# Request for Decision

**To:** Peter de Verteuil, CAO                      **File No:** DP-2018-10  
**Meeting Date:** November 18<sup>th</sup>, 2019                      **Submission Date:** November 8<sup>th</sup>, 2019  
**From:** Michelle Geneau, Manager of Planning  
**Subject:** Development Permit with Variances – 1027 College Street

**Response to Advisory Design Panel Review of  
1027 College Street, 21 Unit Multi-family Development, Duncan, BC**

DP-2018-10 (with Variances) - Attachment A: SITE PLAN

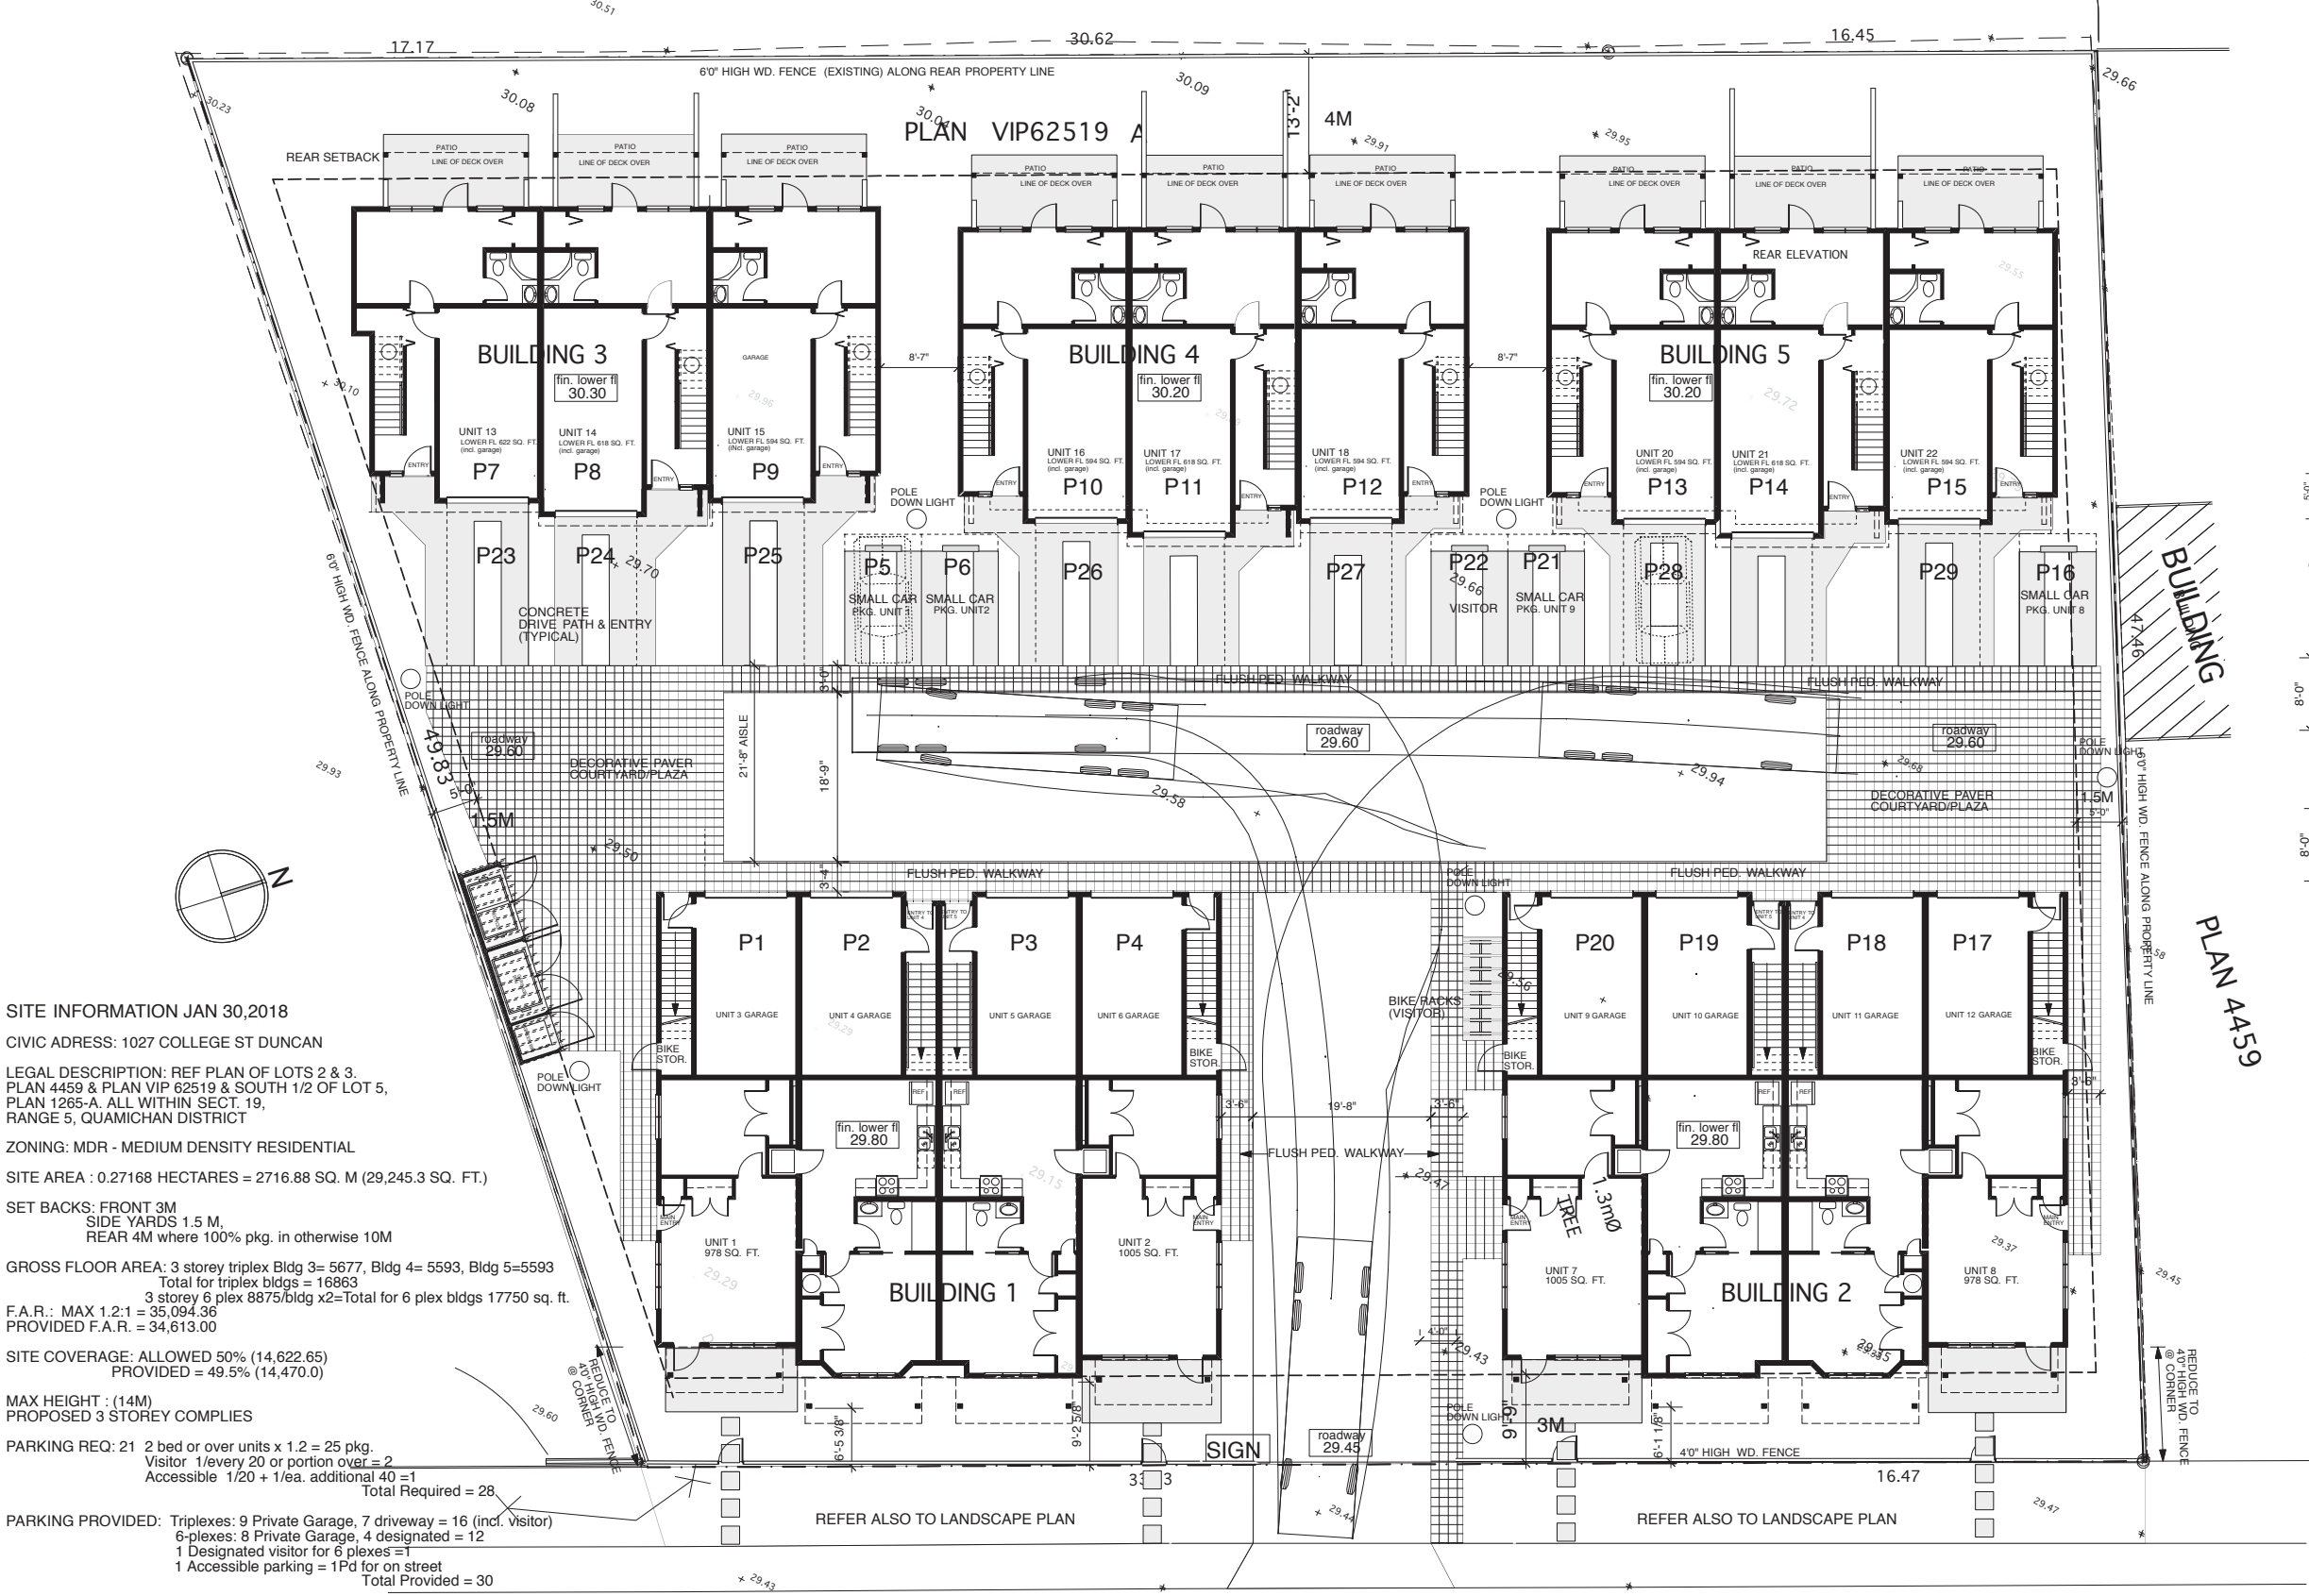
The site plan indicates screened and enclosed garbage/recycling facility will be sited mid-way along the southern interior lot line. A variance will be required to permit its close proximity to the property line (required to be a 1 m setback).

ADP Comments
<p><b><u>Advisory Design Panel Recommendation:</u></b></p> <ul style="list-style-type: none"> <li>▪ Increase permeable surfaces particularly in hardscaping, wherever possible; and</li> <li>▪ Add texture to the pavers along the western side of the driveway access to create a pedestrian walkway to discourage stacked parking and promote garage use.</li> </ul> <p><b><u>Applicant Response:</u></b>  <i>"We propose to amend the driveway access to the rear triplex buildings by creating two 2' wide concrete tracks separated by grass and/or ground cover at each garage driveway. This will increase permeability and landscaped green areas."</i></p>
<p><b>Staff Comment:</b></p> <p>The driveways to the triplexes, and the five additional surface parking spaces were revised after the ADP meeting to have concrete tracks with landscaping in between, and textured pavers were added to the western side of the internal driveway area. However, the ADP discussed discouraging stacked parking (parking inside garages as well as outside of the garages for the tri-plex buildings), as it is not permitted in the Zoning Bylaw, and surface parking encloses or narrows the plaza area. While it would be ideal to eliminate surface parking in front of the nine triplex units, there would still be five surface parking spaces for other units in the sixplexes and the visitor parking space. If the stacked parking variance is denied by Council, a covenant would be required to prohibit parking outside of the triplex garages, which would be difficult for staff to monitor and enforce.</p>

1. Regarding the tri-plex driveways, in order to encourage people to park in their garages we will add a sidewalk in front of the tri-plex driveways using pavers to delineate. This will create a “full circle” in the plaza with an amenity area at both ends. See attached Site Plan

2. We will add the paver demarked amenity space at the south end of the plaza as well. The wood screening around the garbage enclosure and the “open roof” trellis covering with climbing plants will enhance this area. Site lighting will be reviewed to ensure CPTED principles are used. See attached Site Plan

<p><b><u>Staff Comment:</u></b>  Staff is content with this response. Updated site plans and landscape plans incorporate the noted changes.</p>
